DriveLogix™ Controller Firmware Revision 11 / RSLogix 5000 Version 11

These release notes correspond to major revision 11, minor revision 15 of the DriveLogix controller firmware. Use this firmware release with:

Use the Same Tag in Multiple IREFs and OREFs

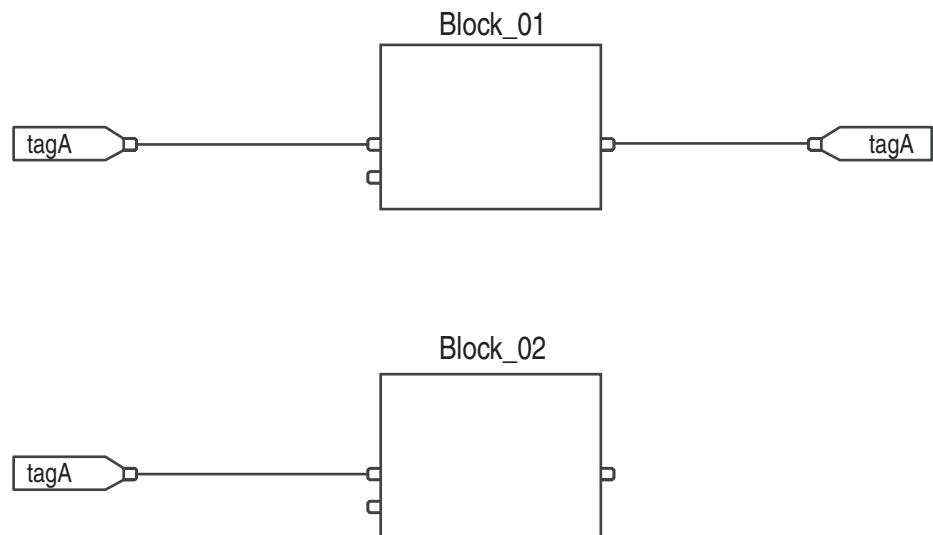
You can use the same tag in multiple IREFs and an OREF in the same routine. Because the values of tags in IREFs are latched every scan through the routine, all IREFs will use the same value, even if an OREF obtains a different tag value during execution of the routine. In this example, if tagA has a value of 25.4 when the routine starts executing this scan, and Block_01 changes the value of tagA to 50.9, the second IREF wired into Block_02 will still use a value of 25.4 when Block_02 executes this scan. The new tagA value of 50.9 will not be used by any IREFs in this routine until the start of the next scan.
